# Technical Service Bulletin

GROUP <b>CAMPAIGN</b>	NUMBER <b>21-01-056H</b>
DATE <b>JULY, 2021</b>	MODEL(S) <b>ELANTRA (CN7)</b>

**SUBJECT:** ICU(INTEGRATED CENTRAL CONTROL UNIT) SOFTWARE UPDATE  
(SERVICE CAMPAIGN T6V)

**ROM ID INFORMATION TABLE:**

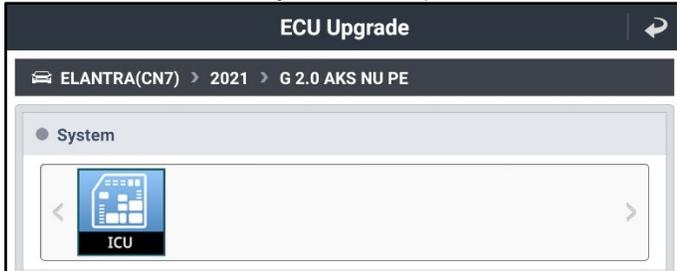
MODEL	SYSTEM	ICU P/N	ROM ID	
			OLD	NEW
Elantra (CN7)	ICU	91950-AA010 ~ 91950-AA990	1.05	1.06
		91951-AA010 ~ 91951-AA590
